MEMORANDUM

RE: 42 Walnut Hill Parkway Site Plan Amendment – Planning Board
meeting April 12, 2023

Date: March 31, 2023

PROPOSED AMENDED SITE PLAN
SHEEBE INC.
 42 WALNUT HILL PARKWAY
 NORTH YARMOUTH, MAINE

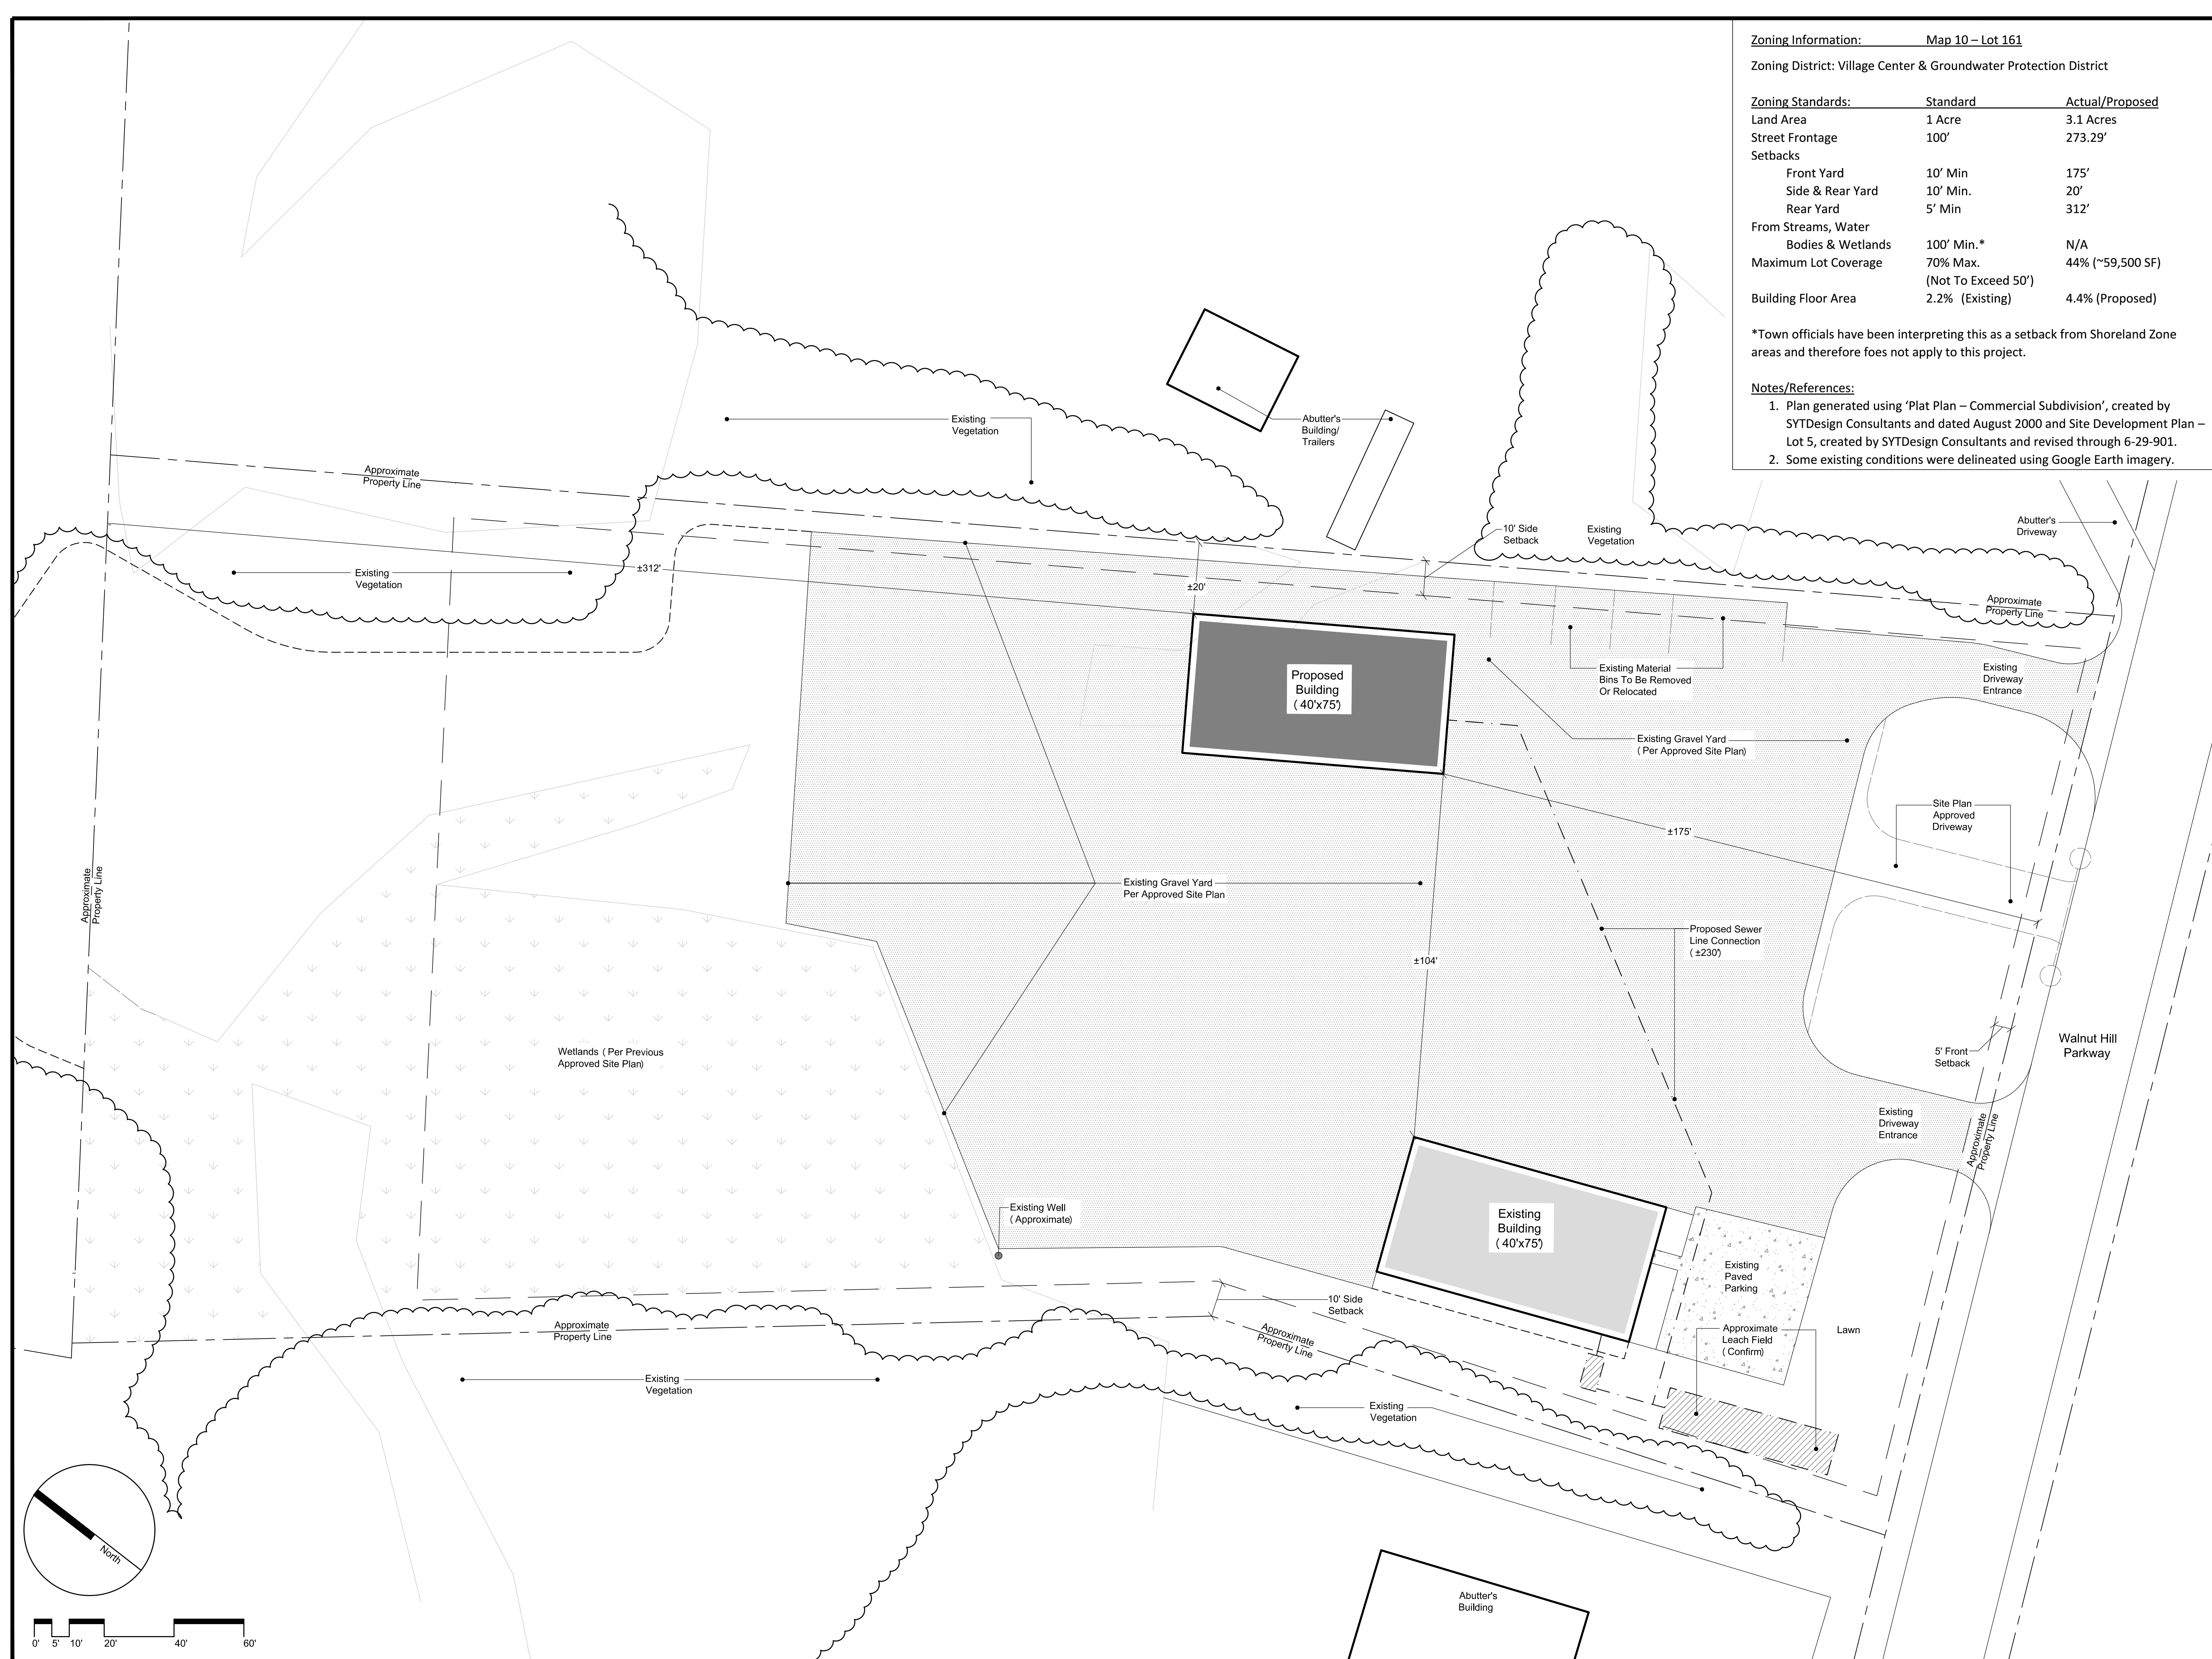
The original site plan consisted of one 30'x100' building and a proposed driveway. The amended site plan shows the existing building, which was constructed at 40'x75', as well as an additional 40'x75' building. The applicant also proposes to amend the plan to keep the existing two driveways, instead of constructing the single driveway from the original approved plan.

- The project is located in the Village Center Zone and is abutted by other commercial/industrial properties.
- The applicant proposes to add a second 40'x75' building, 26' tall, to the site.
- The applicant proposes to amend the driveway from the approved site plan to keep the existing driveways.
- No existing trees or vegetation will be removed for the construction of the new building.
- Existing concrete storage bins will either be removed or placed on a different location on the property.

- The applicant will use existing utilities.
- The applicant will add water and sewer line connections to serve the additional building.
- The subsurface wastewater disposal system was designed for 10 employees. The facility currently has 3 employees and will not exceed 10 employees.

- The applicant proposes to construct a second 40'x75' building.
- The building aligns with the requirements of #13 – Fabrication Building as per Section 10.4 of the LUO.

- Existing concrete storage bins will be removed or relocated on the property.
- There are no abutting residential uses.
- Locations of relocated storage bins will meet setback requirements.

- A stormwater management plan is not required as less than 20,000 SF of land will be disturbed.
- There will be no expansion of the previously approved gravel yard, and no new paving is proposed.
- The applicant owns an experienced site excavation company, and will use proper erosion and sedimentation control practices throughout the project.

- The wetlands delineated on the original site plan will not be impacted by the additional construction.

- The applicant will continue to use the existing driveways.
- The site plan amendment will replace the proposed driveway from the original site plan that was never constructed, with the two existing driveways.
- No increase in traffic will be generated by this project.

Suggested Motion: To approve the 42 Walnut Hill Parkway site plan amendment as submitted pursuant to the Findings of Fact in the memo dated March 31, 2023.
